INSTITUTE FOR RESEARCH IN
ELECTRONICS
& **APPLIED PHYSICS**

Subject: Docket No. 50-166, License No. R-70, University of Maryland.
Submittal of request for license amendment authorizing changes to technical specifications for the use of 16 additional TRIGA fuel elements in the Maryland University Training Reactor

Purpose

Figure 1: Proposed location of additional elements.

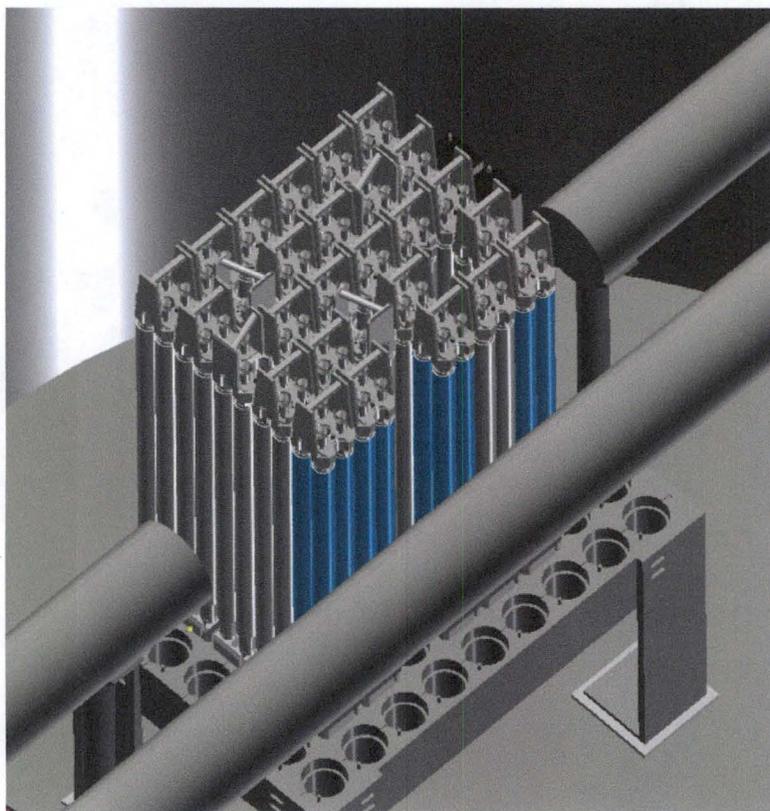
To optimize reactor efficiency while maintaining safety margins, 16 elements will be added to the core, increasing the inventory to 109 elements. The new bundles will be added to grid plate positions nearest the through-tube, indicated in blue in Figure 1.
